# **NUHOMS® EOS System – Application Resubmittal**

May 21, 2015

# **Review/Overview of NUHOMS® EOS System Status and Prior Submittals**

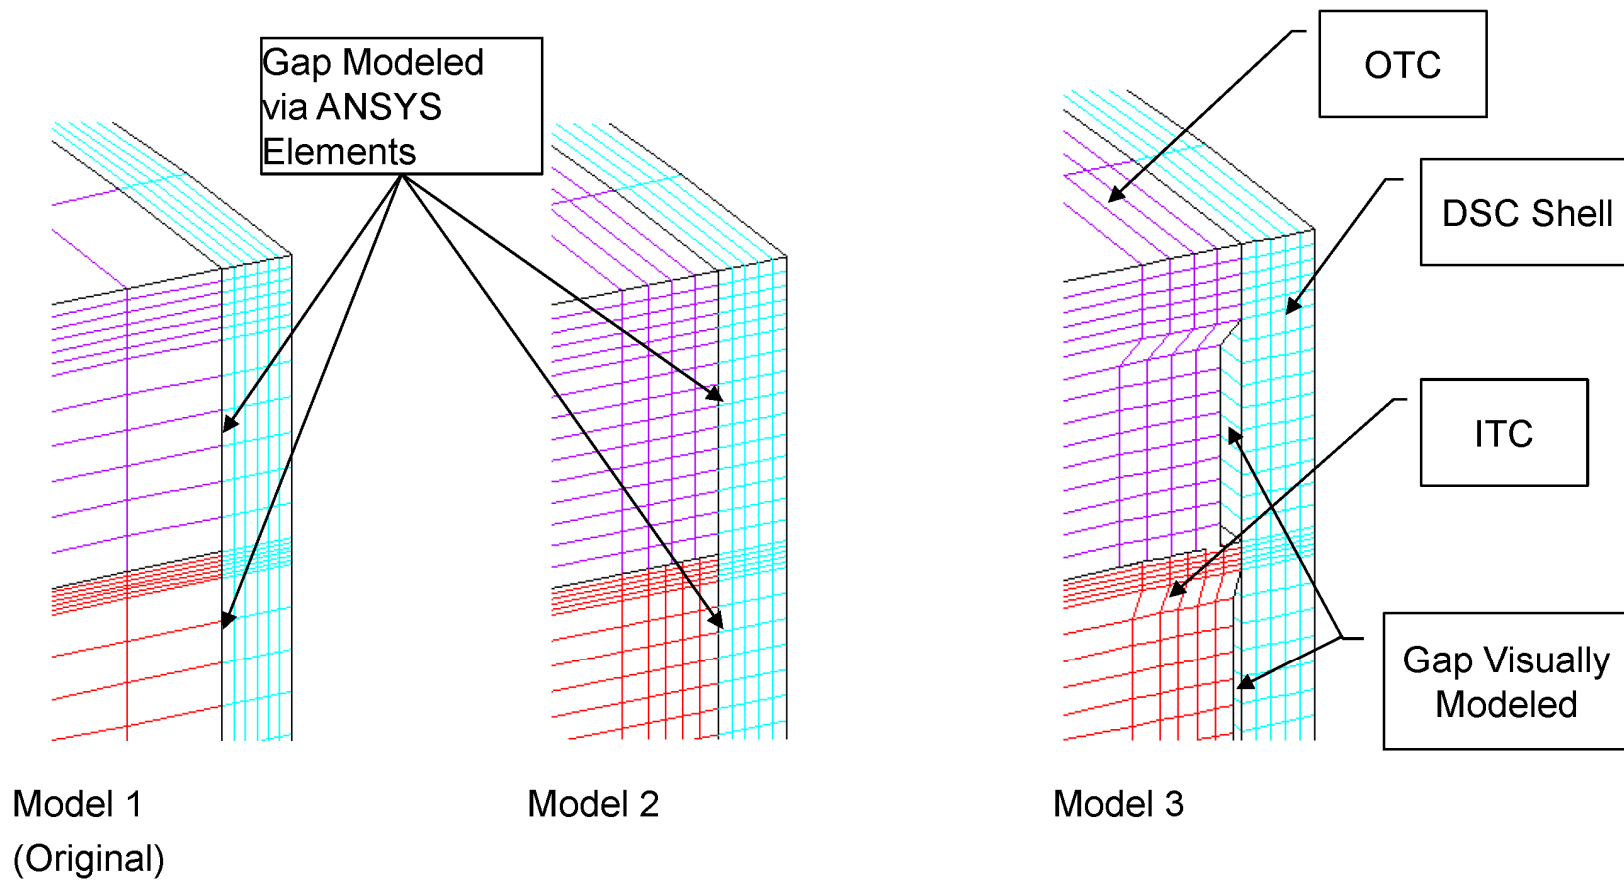
- ▶ **Summary: Effects of gap presence on the calculated weld stress should also be subjected to a sensitivity analysis**

- **Sensitivity study has been performed between three models (preliminary results)**

Model	Gap Modeling Technique	Weld Element Length (Radial Direction)
Model 1 (4/3/15 Submittal)	Via ANSYS element options	0.69 inch
Model 2	Via ANSYS element options	0.17 in. OTC Weld 0.125 in. ITC Weld
Model 3	Visually	0.17 in. OTC Weld 0.125 in. ITC Weld

- **Side drop (75g) loading conditions were applied**

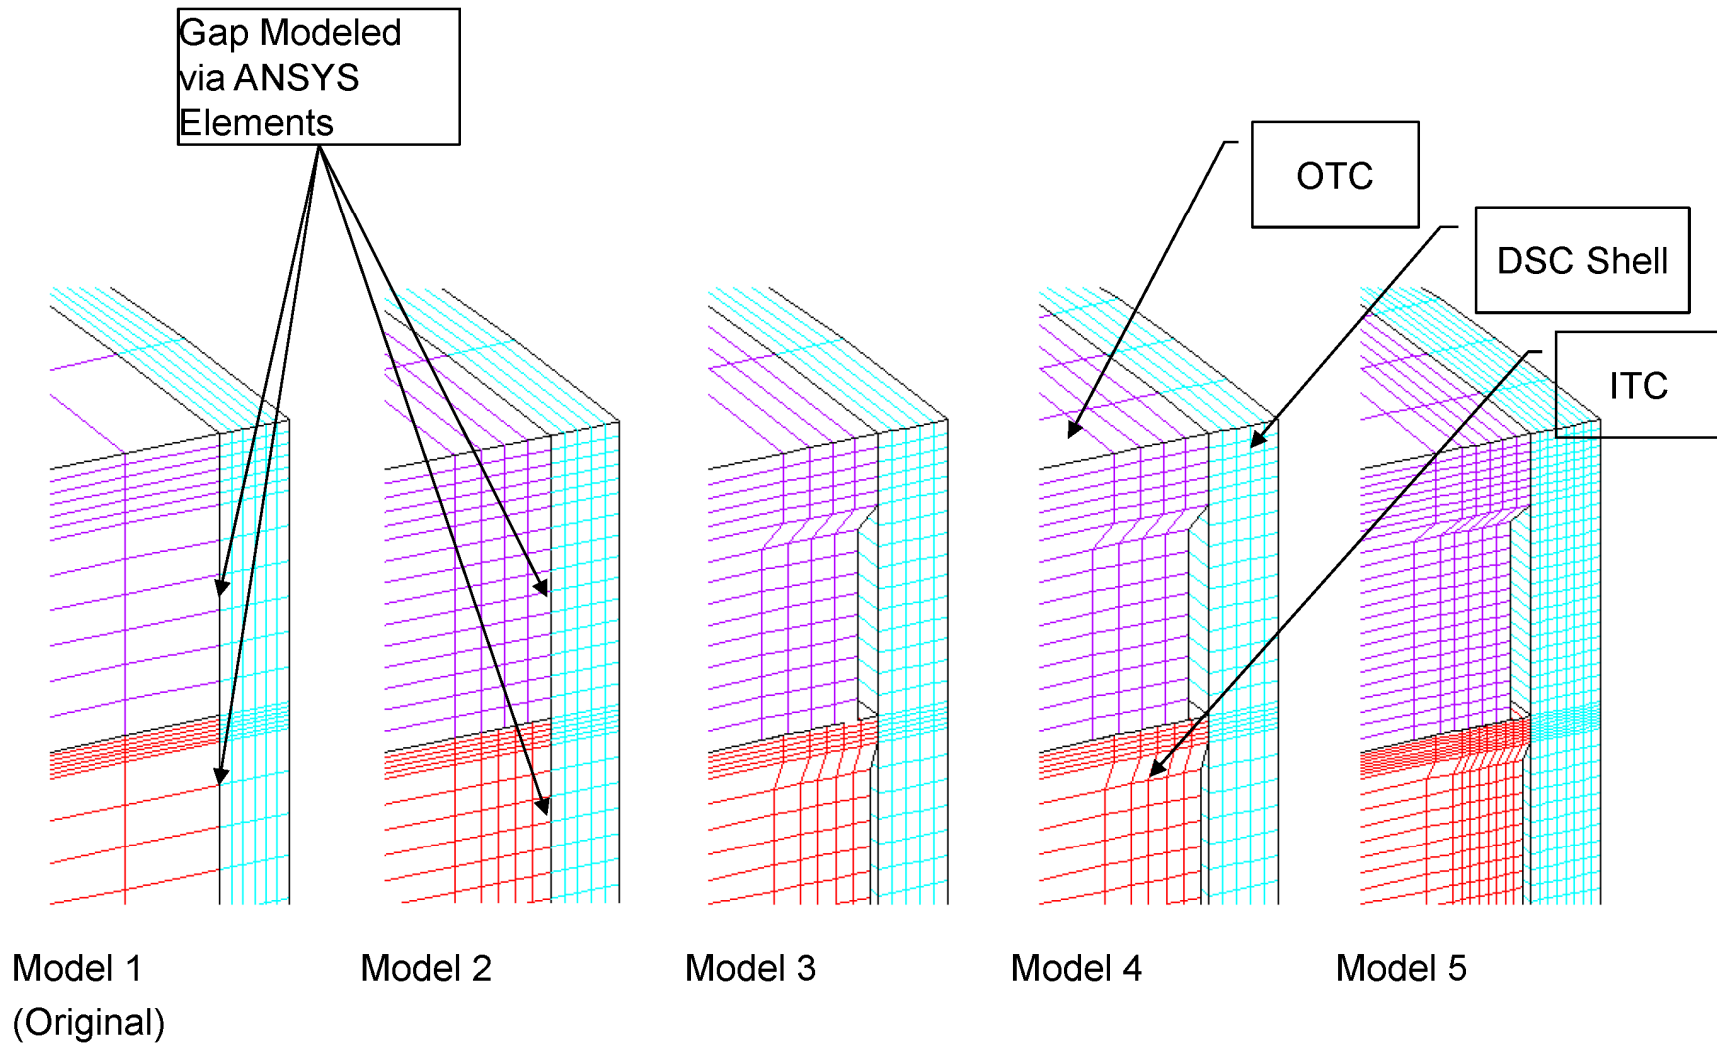
- ▶ **Summary: For an appropriate weld size, a sensitivity analysis needs to also be performed for discretizing the weld into layers in the radial direction.**

- Sensitivity study has been performed between five models (preliminary results)

Model	Gap Modeling Technique	Weld Element Length (Radial Direction)	Weld Element Length (Circumferential Direction)
Model 1 (4/3/15 Submittal)	Via ANSYS element options	0.69 inch	1.4 in
Model 2	Via ANSYS element options	0.17 in. OTC Weld 0.125 in. ITC Weld	1.4 in
Model 3	Visually	0.17 in. OTC Weld 0.125 in. ITC Weld	1.4 in
Model 4	Visually	0.17 in. OTC Weld 0.125 in. ITC Weld	0.7 in
Model 5	Visually	0.10 in. OTC Weld 0.06 in. ITC Weld	0.7 in

- Internal pressure loading conditions were applied

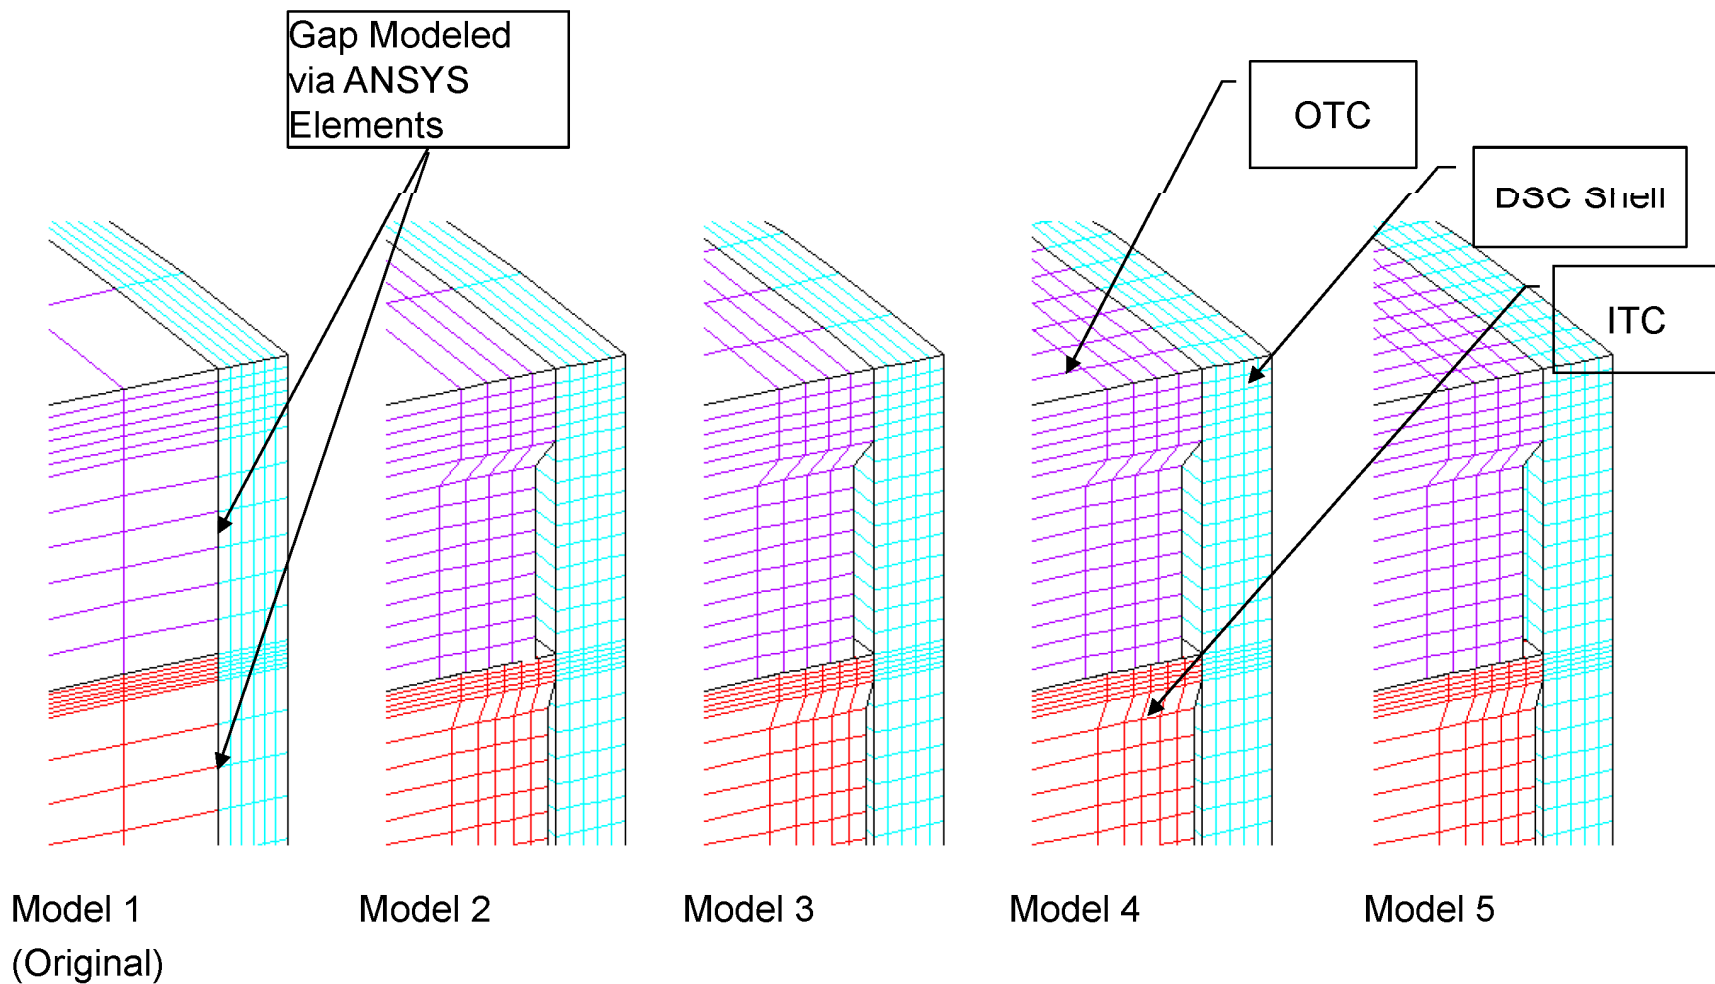
- ▶ **Summary: A 2D mesh sensitivity study does not apply to the 3D side drop scenario; a separate sensitivity study is required for 3D side drop scenario**

- Sensitivity study has been performed between five models (preliminary results)

Model	Gap Modeling Technique	Weld Element Length (Radial Direction)	Weld Element Length (Circumferential Direction)
Model 1 (4/3/15 Submittal)	Via ANSYS element options	0.69 inch	1.4 in
Model 2	Visually	0.17 in. OTC Weld 0.125 in. ITC Weld	1.4 in
Model 3	Visually	0.17 in. OTC Weld 0.125 in. ITC Weld	0.72 in
Model 4	Visually	0.17 in. OTC Weld 0.125 in. ITC Weld	0.36 in
Model 5	Visually	0.17 in. OTC Weld 0.125 in. ITC Weld	0.24 in

- Side drop (75g) loading conditions were applied
